**Multiple Sewershed Package 7B**  
**Solicitation Number: CO-00308**  
**Job No.: 17-4534**

**ADDENDUM 2**  
**October 25, 2019**

**SYMBOLS, ABBREVIATIONS AND SUMMARY OF QUANTITIES**

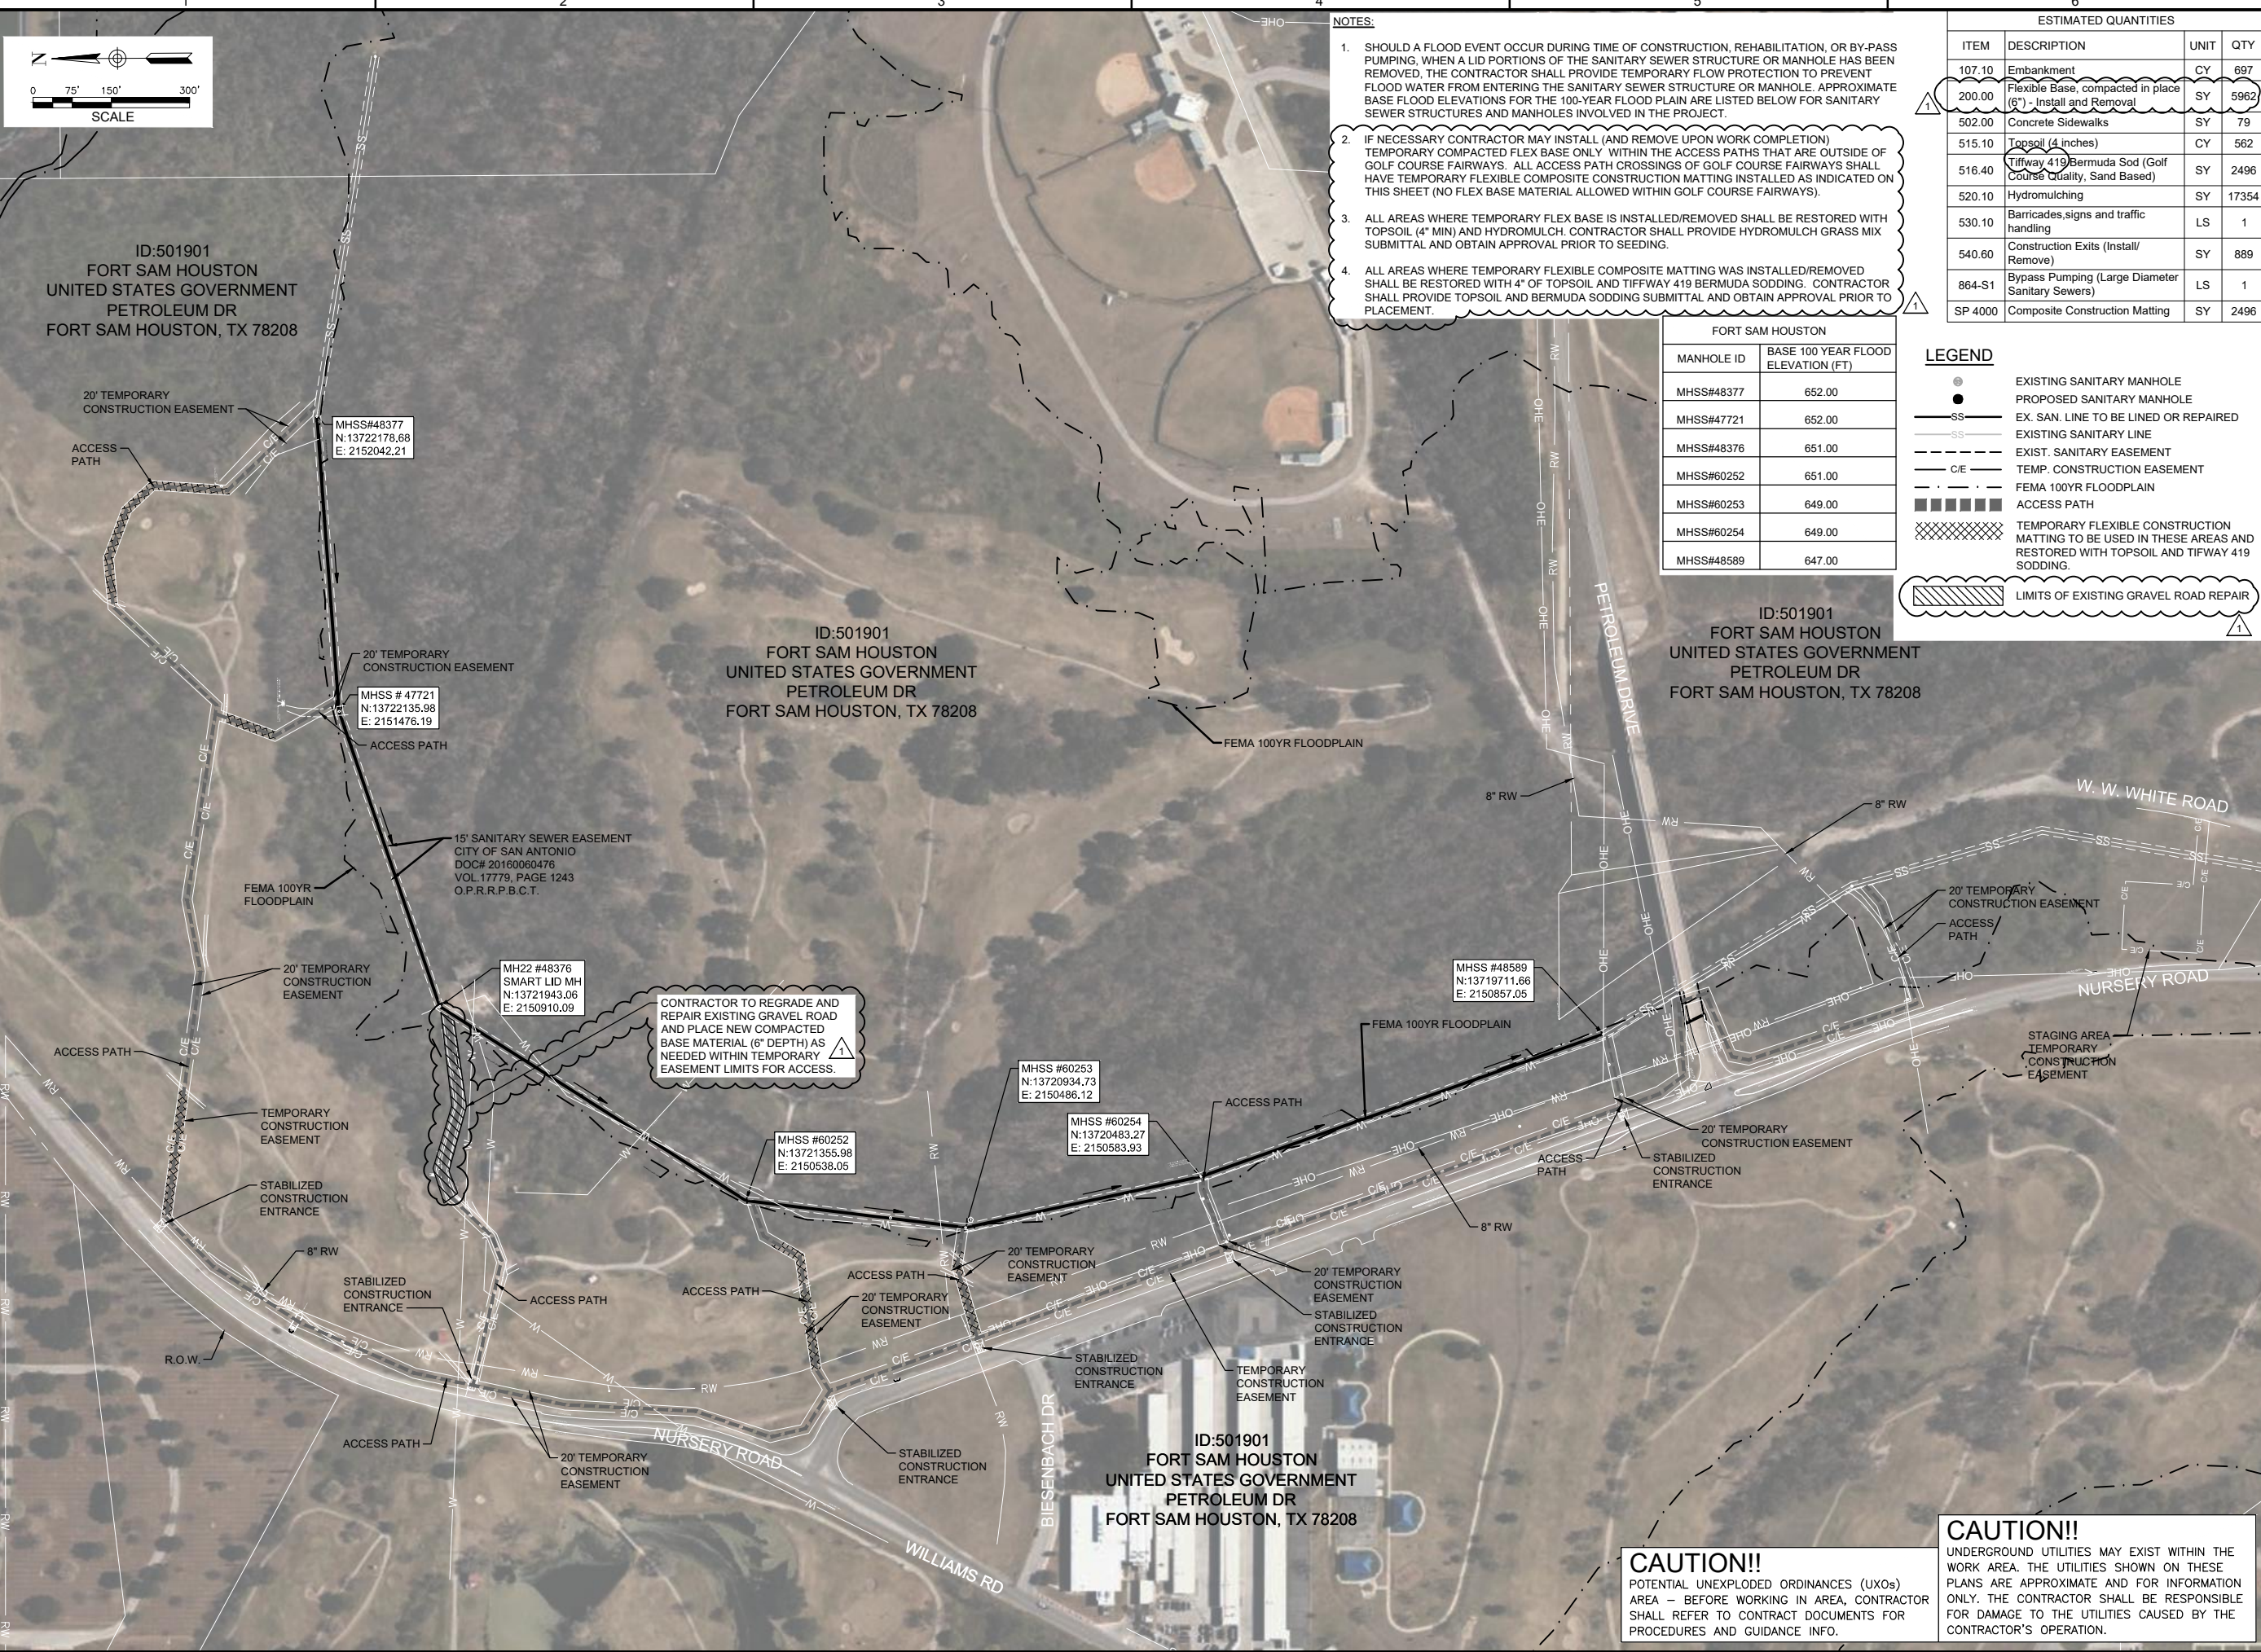
1. Plan sheet 02 (Sheet G02 General Notes and Index of Drawings) – Replace sheet dated 10/4/19 with attached sheet dated 10/23/19.
2. Plan sheet 03 (Sheet G03 Symbols, Abbreviations, and Summary of Quantities) – Replace sheet dated 10/4/19 with attached sheet dated 10/23/19.
3. Plan sheet 06 (Sheet C02 Fort Sam Houston AW47 Site Access Plan) – Replace sheet dated 10/4/19 with attached sheet dated 10/23/19.
